**ADDISON AIRPORT
BUILDING REPORT**

Facility Information: **Facility Name:** 4730 George Haddaway Drive.
Facility Contact: Lisa Pyles **Contact Phone:** 972-450-2878

Accessology Inspector Information:
Inspector: Karen Jackson **Date:** April 17, 2017
Email: Kjackson@accessology.com

Violation 2 - There is a 5-3/16" step up to enter the building.

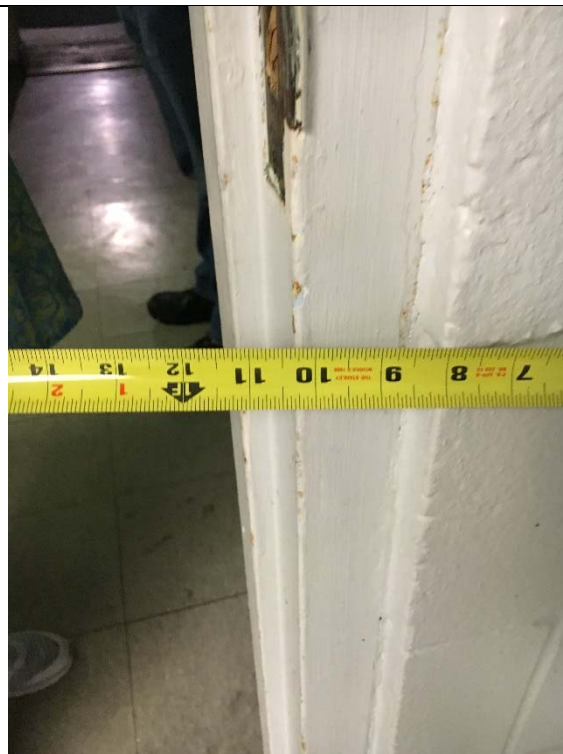
Violation #2: There is a 5-3/16" step up to enter the building.

Replace door with a compliant door that has a threshold no greater than 1/4".

Violation 5 - Men's Restroom: There are 4 lavatories provided and none of them have any compliant features.

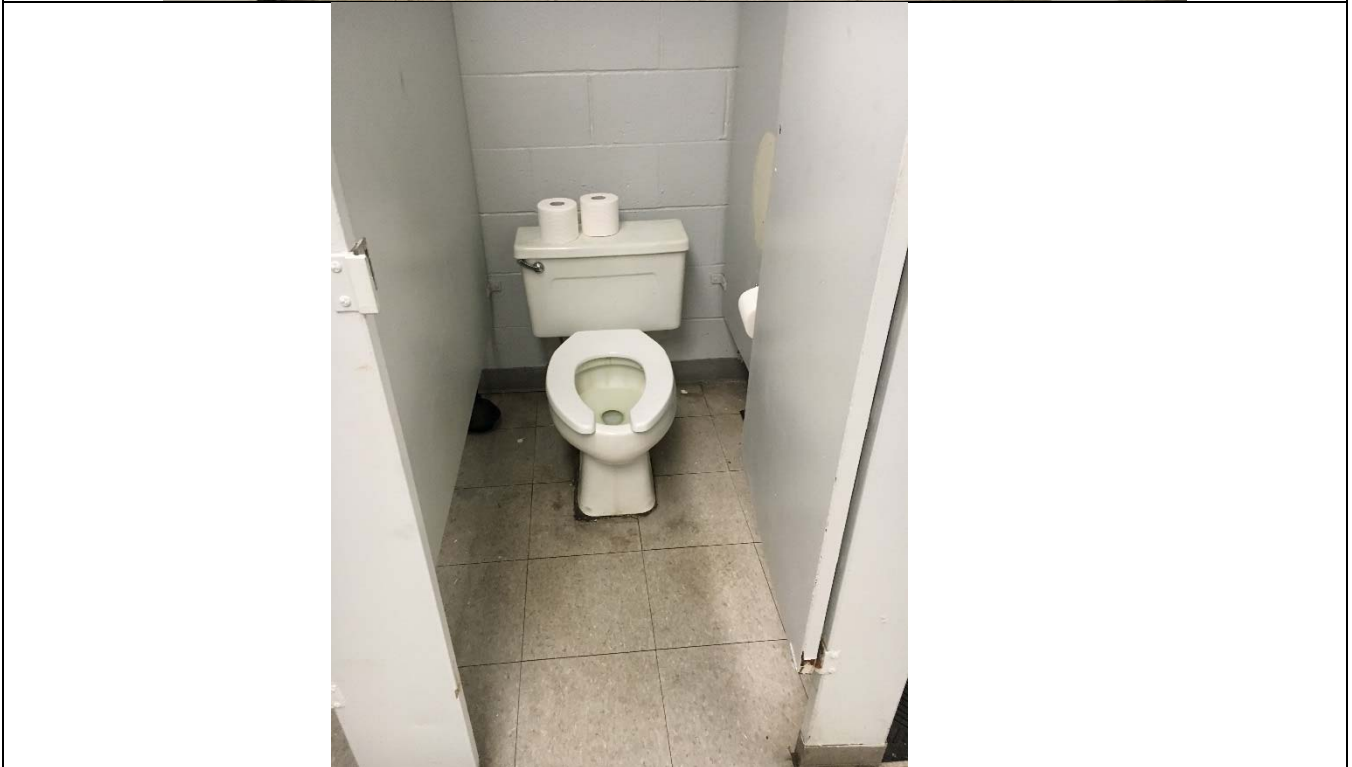
Men's Restroom: There are 4 lavatories provided and none of them have any compliant features.

Install a new, compliant lavatory.

Violation 7 - Men's Restroom: There are no accessible stalls provided.

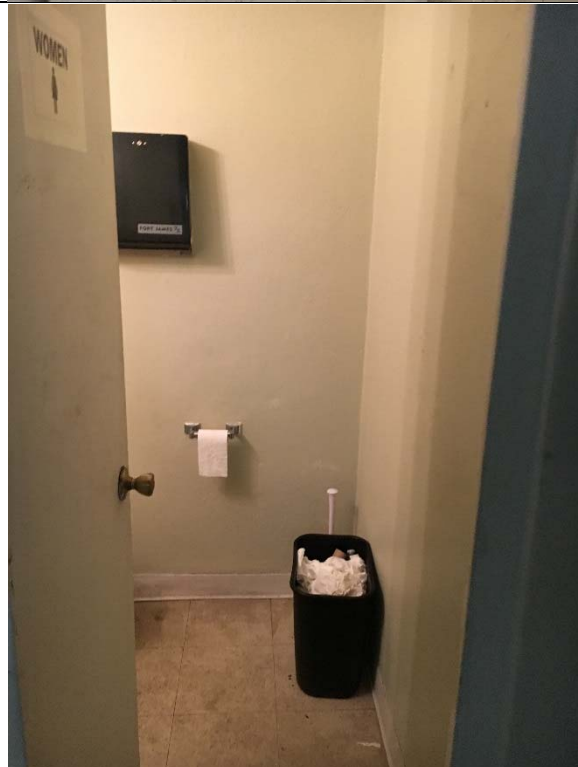
Violation #7: Men's Restroom: There are no accessible stalls provided.

Possible Solutions: Modify partitions to provide a wheelchair accessible compartment. Clearance around a water closet shall be 60" minimum measured perpendicular from the side wall and 56" minimum measured perpendicular from the rear wall.

Violation 8 - The two doors in the facility leading to the Women's restroom have door hardware that requires grasping and twisting to operate.

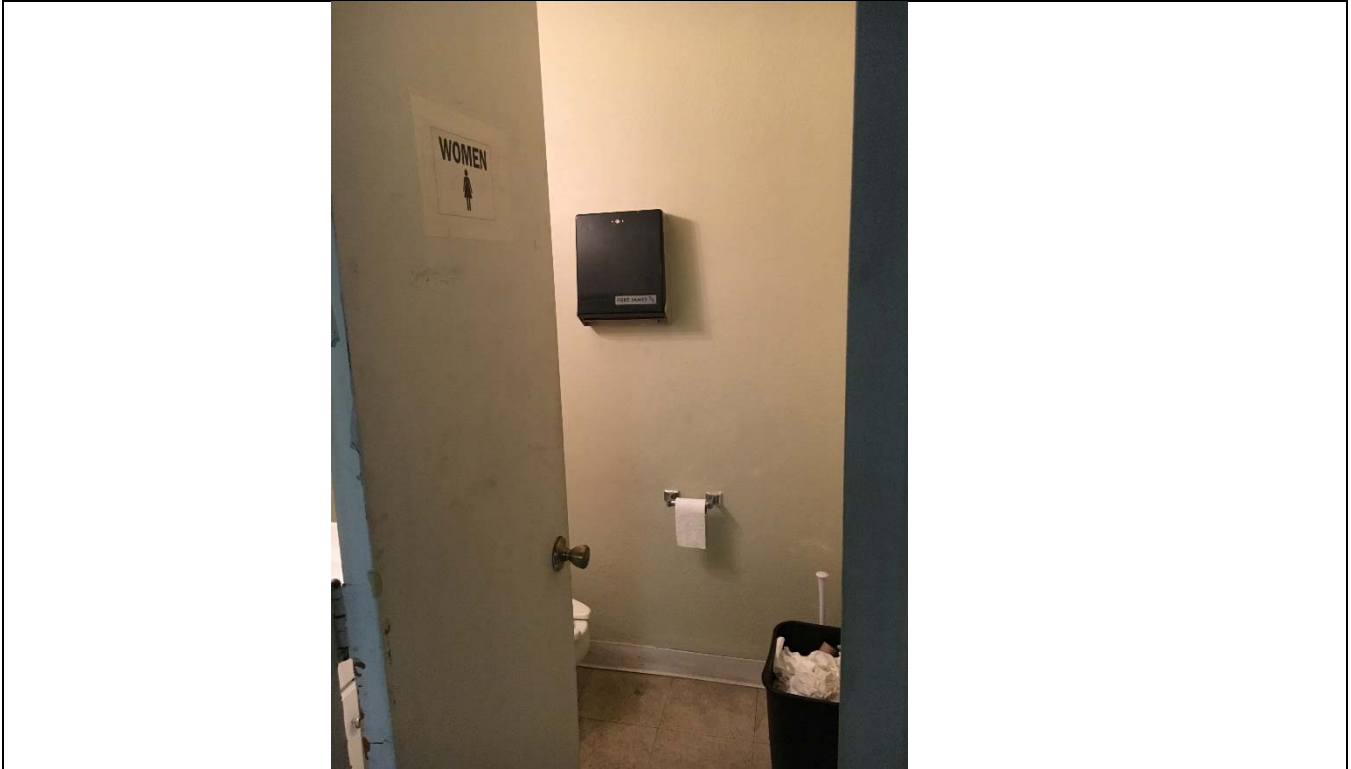
Violation #8: The two doors in the facility leading to the Women's restroom have door hardware that requires grasping and twisting to operate.

Possible Solutions: Replace with lever style door hardware.

Violation 9 - Women's Restroom: Signage is not compliant.

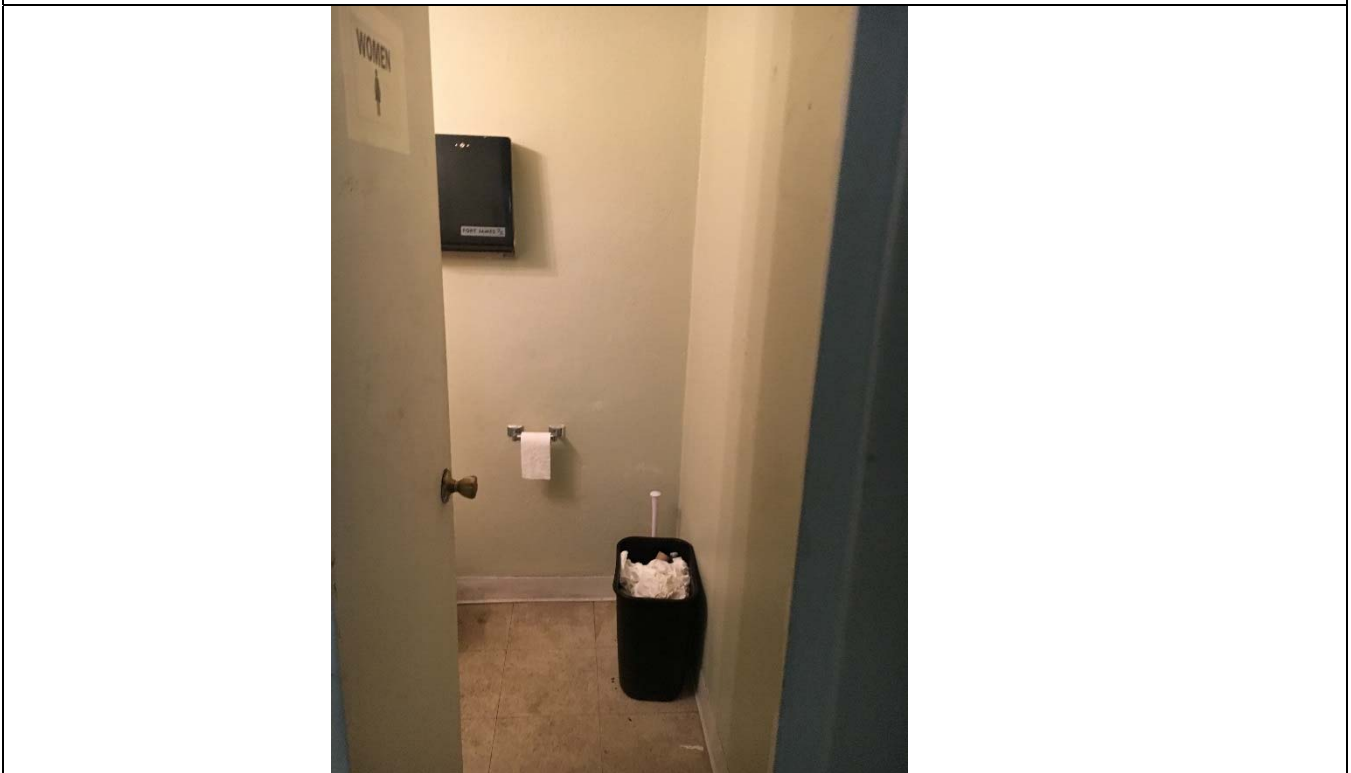
Violation #9: Women's Restroom: Signage is not compliant.

Possible Solutions: Install compliant signage on the wall on the latch side of the door.

Violation 10 - Women's Restroom: Door opening is only 22" wide.

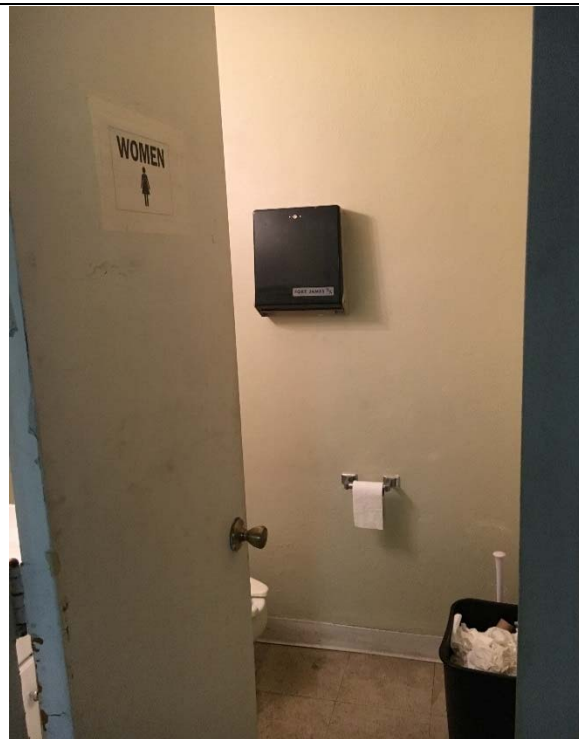
Violation #10: Women's Restroom: Door opening is only 22" wide.

Possible Solutions: Replace door to achieve 32" minimum clear width and reverse the swing of the door.
